## COUNCIL ASSESSMENT REPORT

<b>Panel Reference</b>	2018SWC070
<b>DA Number</b>	DA 1895/2018/JP
<b>LGA</b>	The Hills Shire Council
<b>Proposed Development</b>	Demolition of existing structures, subdivision of land into three lots, construction of local and temporary roads, construction of a residential flat building comprising 60 units and two multi dwelling housing developments totalling 40 townhouses, with basement parking.
<b>Street Address</b>	Lot 69A DP 11104 23-23A Mason Road, Box Hill
<b>Applicant/Owner</b>	J S Architects Pty Ltd Mr and Mrs Yee
<b>Consultant/s</b> Architect: Town Planner: Acoustics: Arborist: Environmental Investigation: Engineering: Traffic: Surveyor: Archaeology: Quantity Surveyor: Accessibility:	J S Architects Pty Ltd DDC Planning Rodney Stevens Acoustics MacKay Tree Management  Geotesta Pty Ltd Indesco EB Traffic Solutions Pty Ltd C and A Surveyors NSW PL Baker Archaeology RIC-QS Pty Ltd JS Architects

<b>report for the Panel's consideration</b>	
<b>Report prepared by</b>	Kate Clinton, Senior Town Planner
<b>Report date</b>	15 October 2020

April 2018

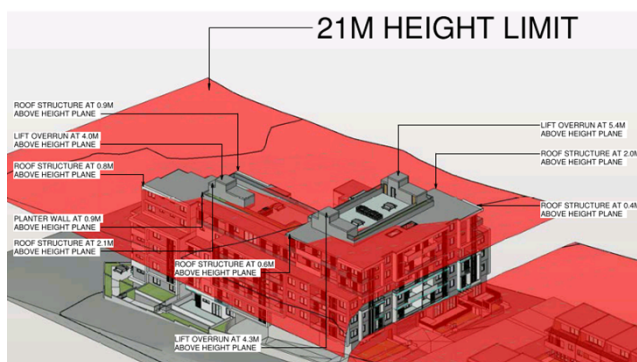
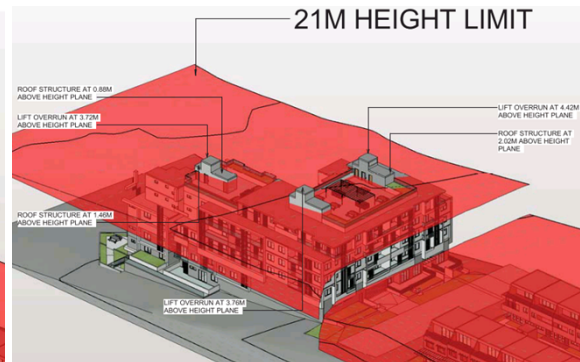
The submitted building height planes (April 2018 and June 2020) indicate that the maximum height of a lift shaft has decreased from 26.4m (5.4m above the height plane) to 25.42m (4.42m above the height plane), being a decrease of 0.98m. Shown in grey in the height plane is a portion of the building located behind the lift shaft (unlabelled) which is over the height limit, in addition to the stairwells and a small corner point of the building, also unlabelled.

The submitted elevations show that the maximum RL has decreased from RL83.83 to RL83.08, a difference of 0.75m.

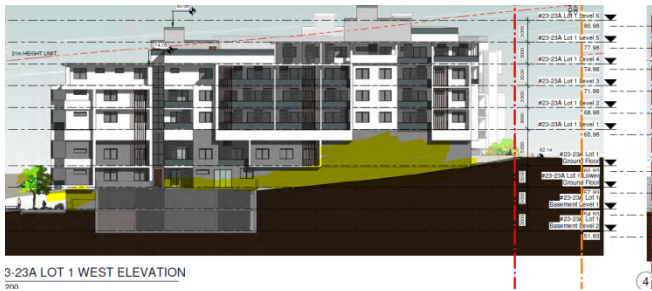
Additional tree cover is required to provide privacy between neighbouring properties, balconies and Common open space, enhance streetscape and increase biodiversity of the area and should be a mix of large canopy native trees and a variety of medium canopy trees where suitable.

- Provide screen planting to boundaries and in front of ground floor units and to reduce height of basement where extends out of ground. Currently the ground floor landscaping consists of two species of groundcovers, two species of grasses, 4 feature shrubs and 13 trees consisting of 2 small to medium sized tree species.

### **Multi dwelling housing**

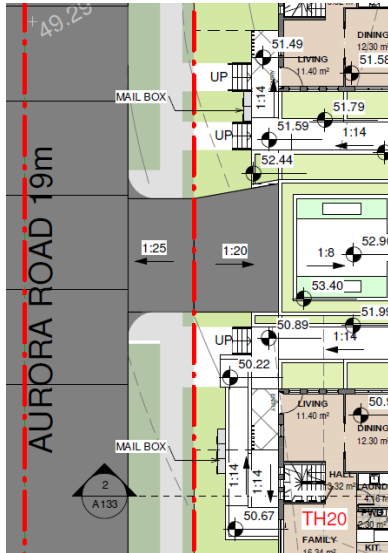
1. Landscape Plans are to be prepared by a qualified Landscape Architect or Landscape Designer as per THSC DCP and indicate the following;
  - All trees planted as part of the approved landscape plan are to be minimum 75 litre pot size. All shrubs planted as part of the approved landscape plan are to be minimum 200mm pot size and plant spacings to be between 500mm to 2m depending on species. Groundcovers are to be planted at 5/m<sup>2</sup>. The proposed densities of planting are to be amended.

- Additional variety of tree, shrub and groundcover species is to be included in the planting palette for a development of this size. Plant species selected are also to be suitable to microclimatic conditions created by the built form. In particular the southern boundaries which will be heavily shaded.

#### Residential Flat Building

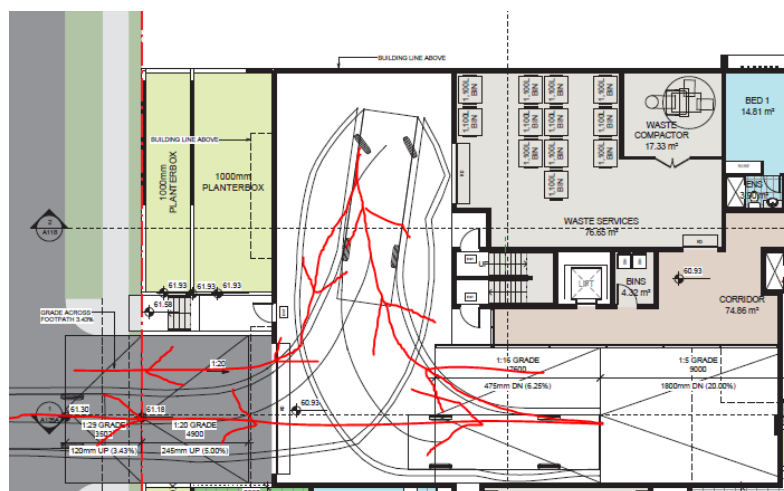
future road (Tucana Street) and turning out of the site onto the future road. Swept turning paths must also demonstrate that two-way traffic flow can be achieved between waste collection vehicles and the standard B99 passenger vehicle (AS2890.1) at the footpath crossover and driveway when collection vehicles enter and exit the site. Waste collection vehicles must not encroach onto the oncoming traffic lane.

## **Lot 2 and 3 – Townhouses**

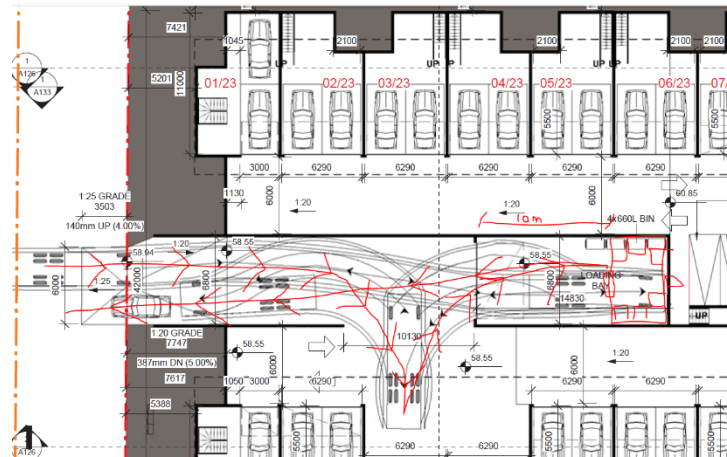
1. Similar to point 5 for Lot 1 – Residential Flat Building, the swept turning paths overlaid on the plans for Lots 2 and 3 – Townhouses show waste collection vehicles entering the loading area in a forward direction and reversing onto a trafficable internal carpark aisle. This raises vehicular conflict concerns as waste collection vehicles will not have the best visibility whilst performing this manoeuvre. It is noted that the swept turning paths in the traffic report dated 21 April 2018 show the collection vehicle reversing into the loading area, however it is also noted that the layout design of the carpark has changed since the traffic report was drafted. Swept turning paths must be submitted and overlaid on the current car park layout design showing the standard 8.8m long Medium Rigid Vehicle (AS2890.2) reversing into the loading area from an internal turning bay. See indicative mark-below.

2. Similar to point 6 for Lot 1 – Residential Flat Building, the swept turning paths overlaid on the plans for Lots 2 and 3 and the swept turning paths provided in the traffic report dated 21 April 2018 show waste collection vehicles entering the site(s) at a perpendicular angle. Swept turning paths must be submitted demonstrating the standard 8.8m long Medium Rigid Vehicle (AS2890.2) turning into the site(s) from the future roads (Aries Way and Aurora Road) and turning out of the site(s) onto the future roads. Swept turning paths must also demonstrate that two-way traffic flow can be achieved between waste collection vehicles and the standard B99 passenger vehicle (AS2890.1) at the footpath crossover and driveway when collection vehicles enter and exit each site. Waste collection vehicles must not encroach onto the oncoming traffic lane.
